**SAMPLING AND ANALYSIS PLAN  
FOR  
“Geotechnically Unsuitable Soils”**

**Massachusetts Clean Energy Center**

**New Bedford, Massachusetts  
August 12, 2013**

**Prepared by:  
Apex Companies, LLC  
New Bedford, Massachusetts  
Boston, Massachusetts**

Stockpile A1 : 60' x 45' x 10'

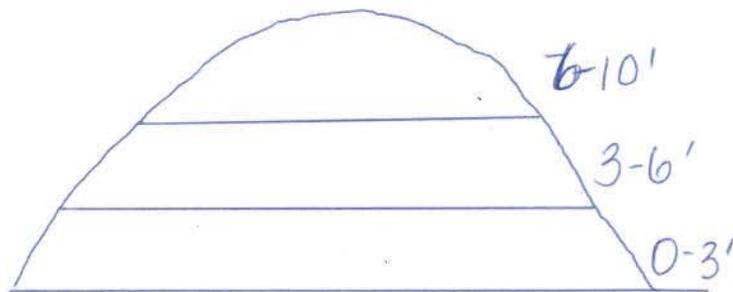
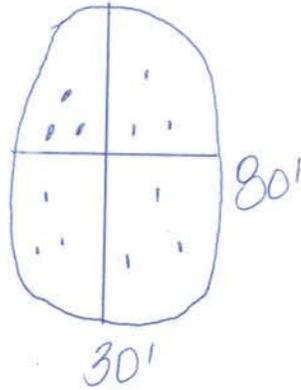
Conceptually, the stockpile SAP currently being discussed would appear to be sufficient to determine whether a stockpile is < 50 ppm or > 50 ppm for off-site disposal purposes. However, as I discussed with Mike today, I believe that a more systematic approach to grid sampling of piles is more defensible than just using a volume estimate. Attached are examples of a sampling protocols for several different stockpiles varying in both size and dimension. The approximate # cubic yards per sample shown in these examples is smaller than 1 sample per 100 cubic yards, so I am willing to discuss once you have an opportunity to review. ( Please no comments on my artistic ability.....)

EACH SUBGRID = 30' x ~22.5'

4 grids total

3 "discrete sample" / grid

- ∴ Each level has 4 grids x 3 levels = 12 "composite samples" total
- Each composite sample comprised of 3 discrete samples
- Each grid represents 75 yd<sup>3</sup> for this pile

STOCKPILE B1: 30' x 80' x 10'

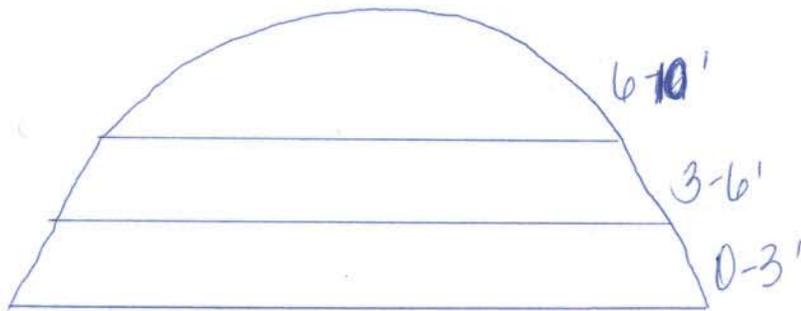
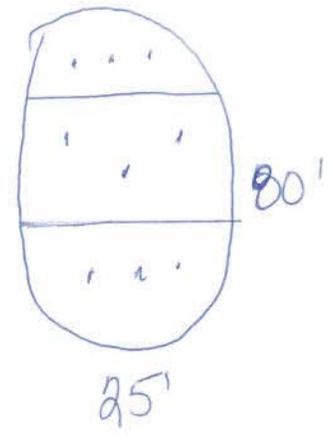
Each grid = 40' x 15'  
4 grids w/ 3 discrete samples/grid

Each grid represents ~ 67 yd<sup>3</sup>

∴ 4 grids/level x 3 levels = 12 "composite" samples

STOCKPILE **D1** 25' x 80' x 10'

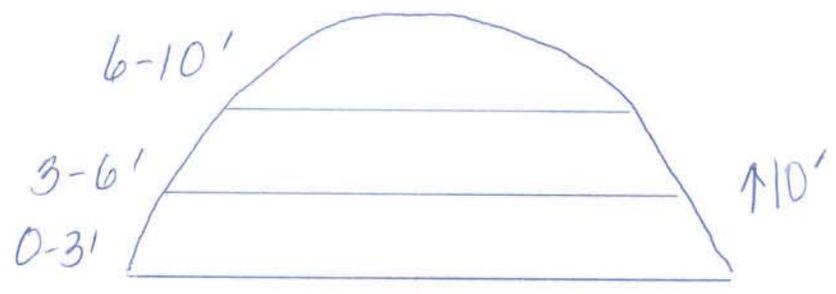
3 grids : ~ 27' x 25'  
3 discretos/grid

Each level has 3 grids x 3 levels = 9 samples (composite)

Each grid represents ~ 75 yd<sup>3</sup>
